Reply to Office Action of October 1, 2009

S/N: 10/599,571
Reply to Office Action of October 1, 2009

Atty Dkt No. JANS0101PUSA

The following picture below shows an example of ligament flow from a flow module as described in the application.

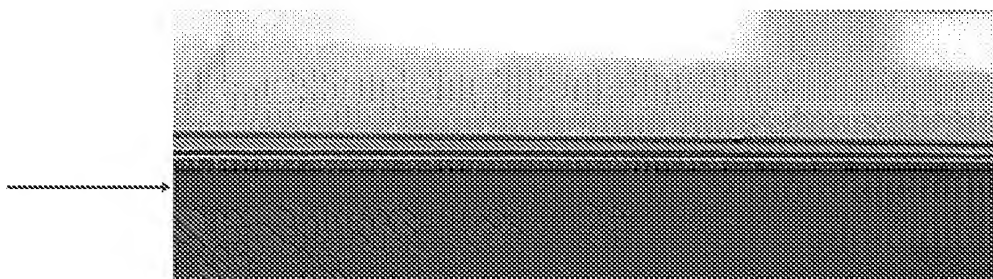
Claim 20 as amended requires "the spray system with flow distribution modules is illuminated in the area on the lips where ligament flow occurs during spraying, and a vision system is used to count the ligaments." (emphasis added). The Examiner states that "the use of a camera to analyze the flow from an electrospray apparatus is known in the art, as exemplified by MILLER, which discloses an electrospray apparatus (2) with a window (42) and an optical sensor (5) for generating and image of the spray". (Page 13 of the Office Action of October 1, 2009).

Miller et al. teaches a system having a camera 50 positioned in close proximity to an atomized plume of an individual nozzle ("the viewing orifice 46 is positioned . . . about 20 to 50 millimeters from the axis of the atomized plume. (Miller et al., Col. 4, lines 20-24). Placing a camera 20-50 mm from a high voltage source (40-65kV in Wichmann, Col. 10, lines 7-24) is not recommended due to arcing. The combination of Wichmann and Miller et al. does not teach or suggest a vision system for counting ligaments, and claim 20 is nonobvious over the Examiner's combination.
